Technical Service Bulletin

00 PDI inspection - IQS supplement

00 13 57 2035669/2 November 11, 2013. Supersedes Technical Service Bulletin Group 00 number 13-56 dated November 1, 2013 for reasons listed below.

Model(s)	Year	VIN Range	Vehicle-Specific Equipment
A6, A7, Q5, Q7	2014	All	Not Applicable

Figure 6. Location of the assembly support strap along A pillar trim bracket.

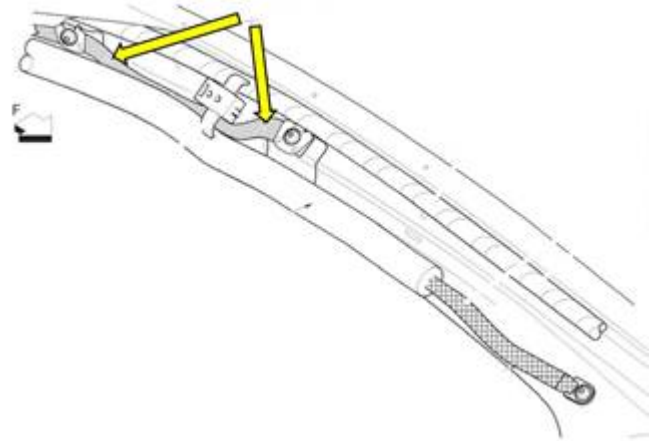
- When installing the new trim make certain that the assembly support strap is not trapped or pinched between the adapter and the A pillar structure (Figure 6).
